AGENDA
PLANNING AND ZONING COMMISSION MEETING
CITY OF CREVE COEUR, MISSOURI
MONDAY, JULY 6, 2015
7:00 PM

APPLICATION TO PLANNING AND ZONING COMMISSION #15-001 FOR SITE DEVELOPMENT PLAN OF AN OFFICE BUILDING AT 844 N. NEW BALLAS COURT

REPORT PREPARED BY: Whitney Kelly, AICP, City Planner
DATE: July 1, 2015
ATTACHMENTS: Revised Drawings submitted July 1, 2015

Landscape Plan
1" = 10'-0" 3-30-2015
This Landscape Plan is the exclusive property of Horstmann Brothers, LLC Landscape Services.
Any reproduction of this plan without expressed written permission from Horstmann Brothers, LLC Landscape Services is strictly prohibited.

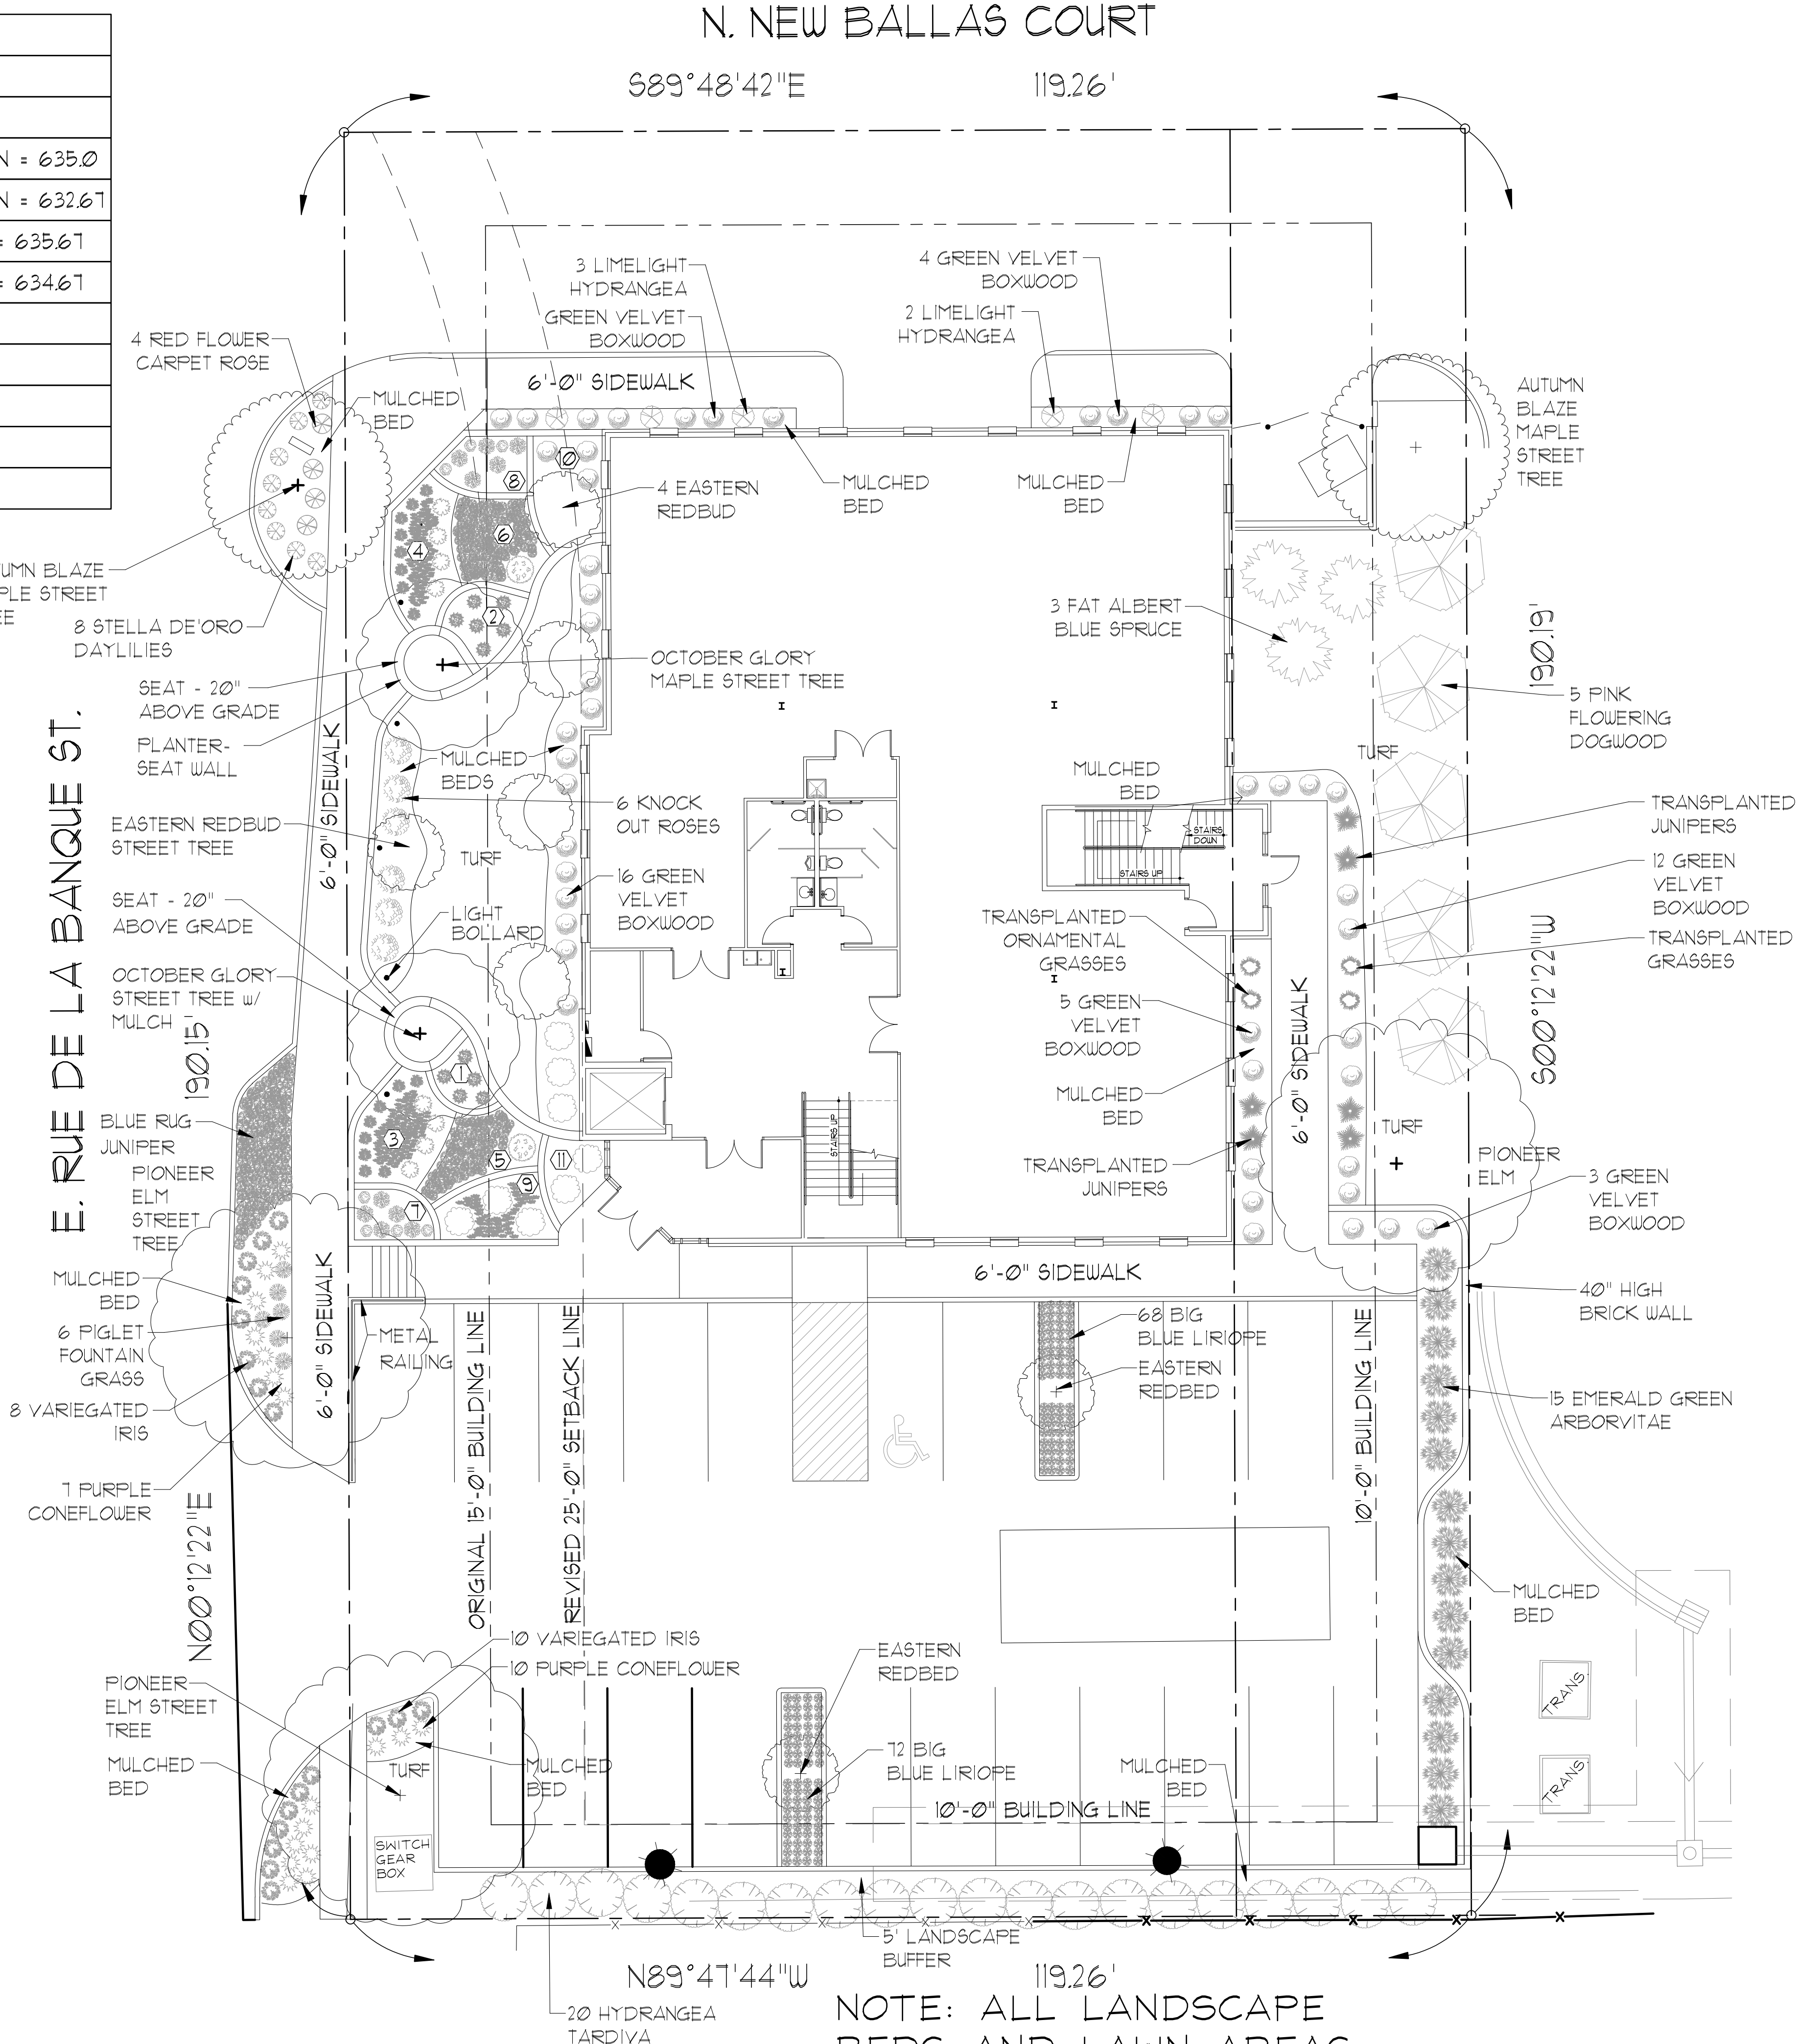
Request #4: We request that the approved plan include a 40 inch high brick wall along the east side of the south parking lot to screen the parking lot from the view of residents at CityPlace Condominiums. *We noticed that the originally proposed (i.e., March 2015 proposal) 30" versalock wall was eliminated from the revised plans of June 15, 2015.*

Request #5: We request that the approved plans include additional plantings to supplement the landscaping on the east side of the building. This would enhance the view of the condominium residents facing west, and maintain the high quality appearance of the landscaping planned for the east side of the building.

- on the turf side facing east between the row of five dogwoods and the mulched bed along the employee sidewalk, four red buds to be planted in an alternating row with the dogwoods, allowing for complementary coverage as well as understory protection for the dogwoods.

- in the mulched beds surrounding the employee sidewalk to the east of the building we would like to request the commission require limelight hydrangeas and green velvet boxwood as shown on the north side of the property in lieu of transplanted junipers, green velvet boxwood, and transplanted grasses,.

- the plans for the parking lot show a 5 foot landscape buffer planted with 20 hydrangea Tardiva along the south side of the parking area. We would like to request consideration of a landscape buffer in the north east corner of the parking lot just south of the pioneer elm (two parking spaces facing north), perhaps three of the hydrangea tardiva for consistency or 3 to 5 of the limelight hydrangea.

Figure 1: Proposed West Elevation

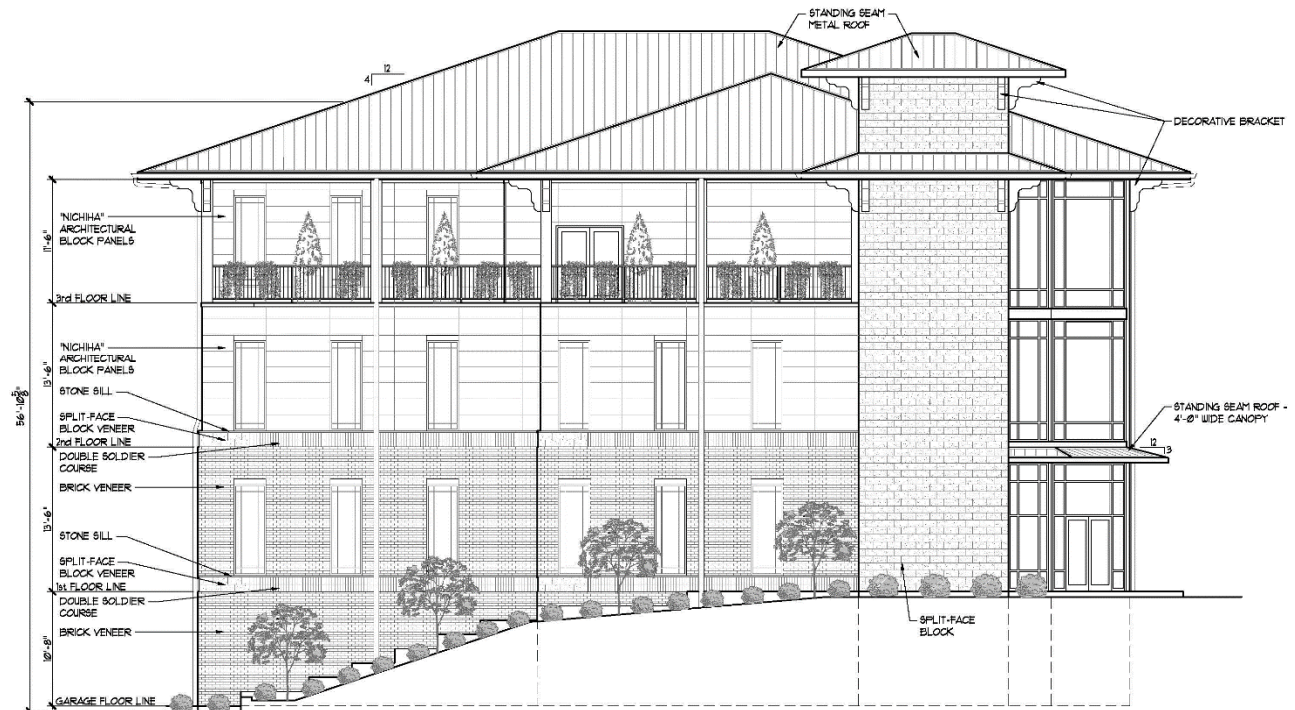
1. The materials of the building are the same as prior review consist, brick and split-face block, and architectural panels for the second and third floor. The roof is still a standing-seam metal roof. There seems to be a lack of a distinct design style; a mix of traditional residential design and modern office elements that the Applicant refers to as "fusion architecture." The Design Guidelines recommend incorporating a clear and well-articulated design concept. The Applicant's assertion that they are following the example set by the Danforth Plant Science Center misses the overall concept of the building wherein the Danforth Center is utilizing a modern-looking terracotta panel in a modern design throughout, versus the Applicant's use of the similarly modern "Nichiha" Architectural Block Panels on a traditional building form. On the other hand, the example of the PNC Bank exterior utilizes the more traditional brick finish on the traditional building style. Staff finds that the overall style of the building would be greatly enhanced if it were to be all a more traditional finish such as stone and brick.

The west elevation has been redesigned to have 44 feet of the building façade setback 25 feet from the property line, with 31 feet setback an additional 2.5 feet. This helps to create additional interest in the elevation and meets with the Zoning Ordinance requirement that 50% of the building be within the maximum building setback (as modified by the variance).

Figure 3: Close-up of the proposed Landscape Plan.

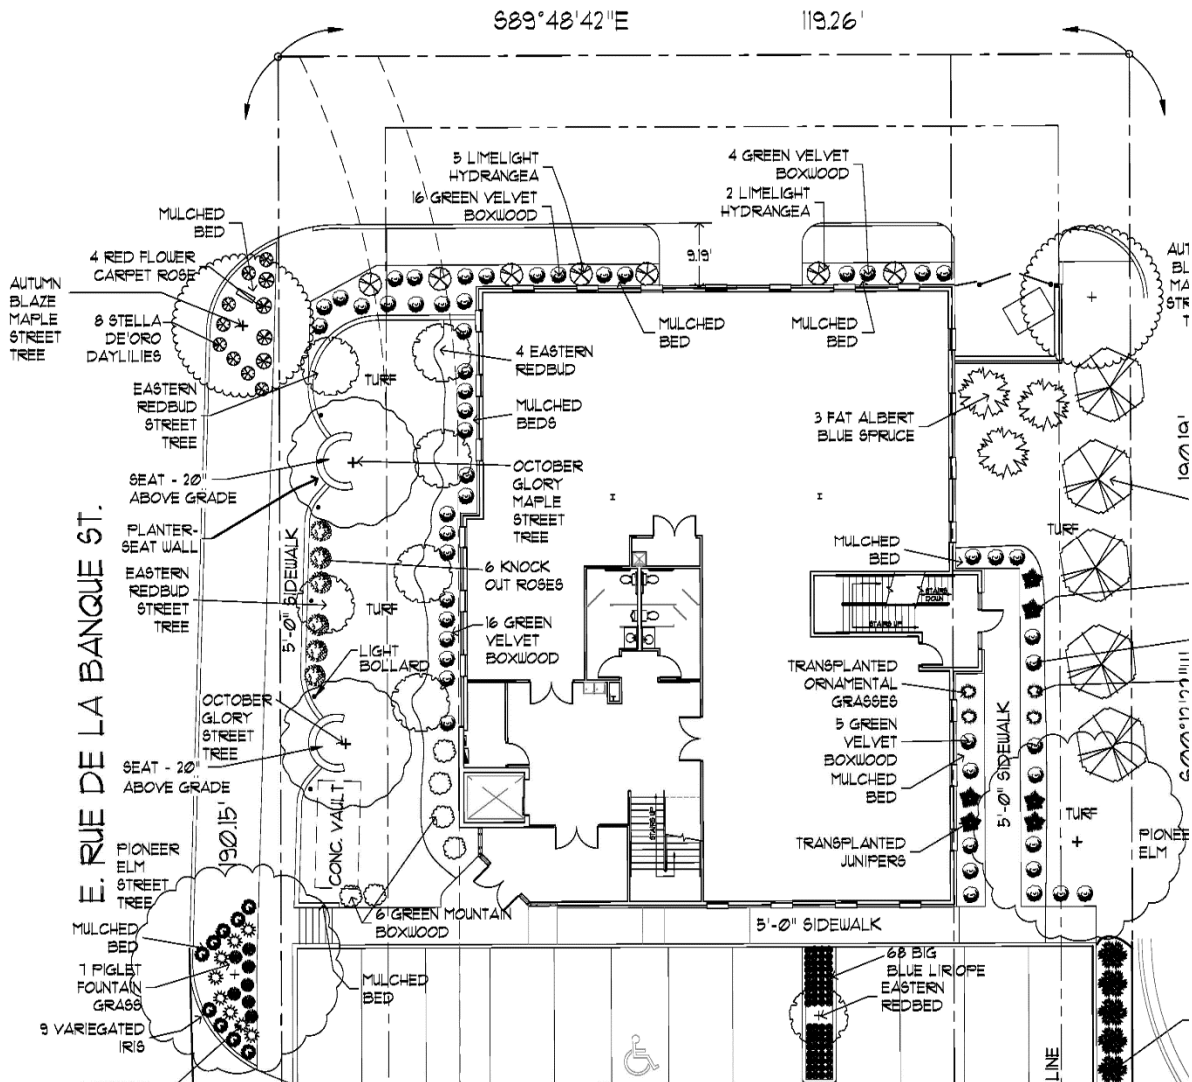
4. **Landscaping:** As discussed in the prior Staff Report, the Applicant's Landscape Plan meets with the minimum requirements regarding the number of street trees and screening of the parking lot. Additional landscaping has also been included within the parking lot and the terraced retaining walls next to the building. However, as discussed at the February 17th meeting, the addition of a low fence or wall would greatly improve the efficacy of the screen and should be considered by the Planning and Zoning Commission. A related condition of approval has been recommended below.

Picture 6; Car bumper 2' from the edge of garage.

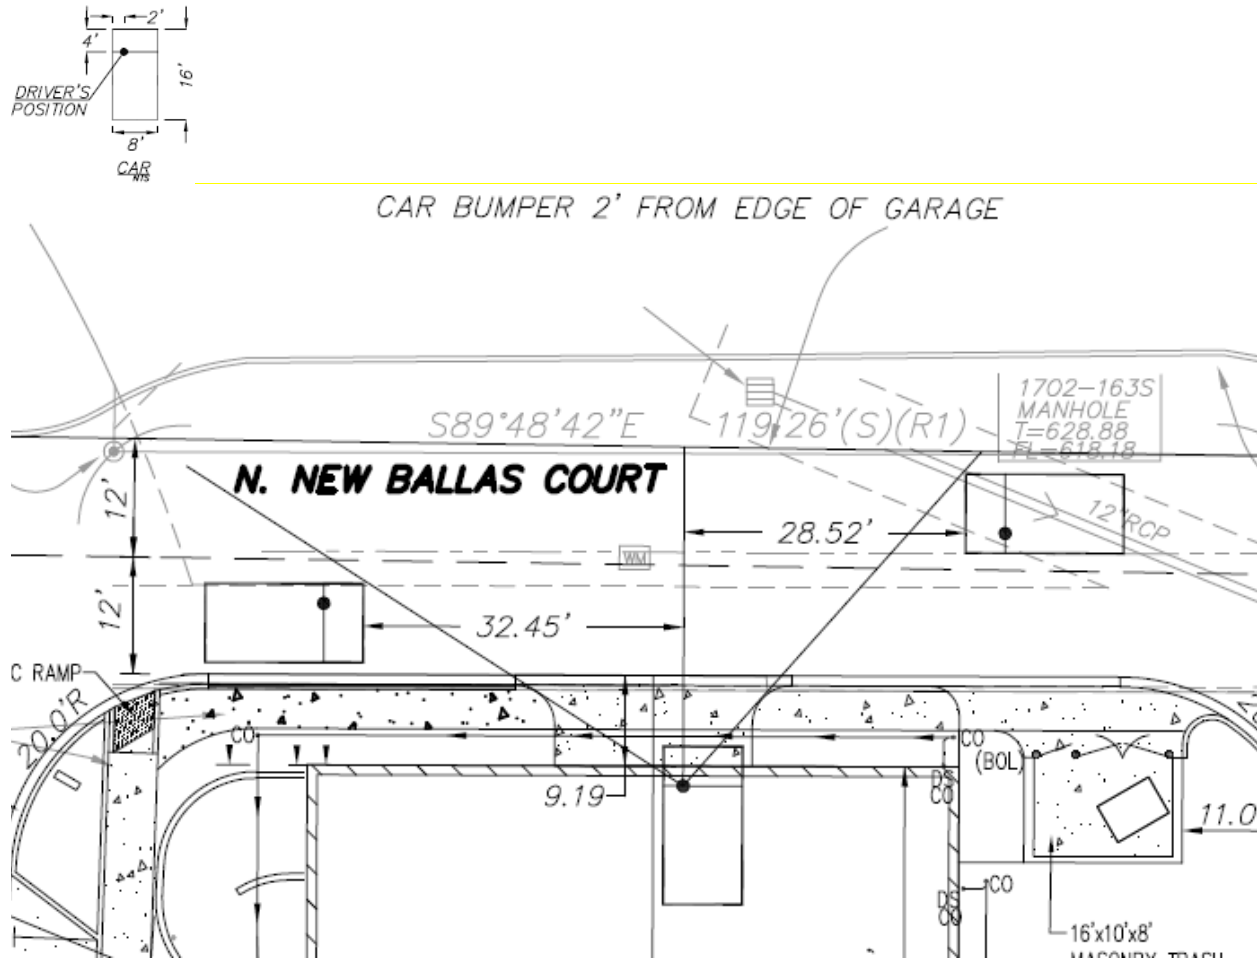
- i. When the front bumper of the car is 2' from edge of garage the driver could see a vehicle going west on N. new Ballas Court at 28.52' and a vehicle going east on N. New Ballas Court at 32.45'. Picture 6.
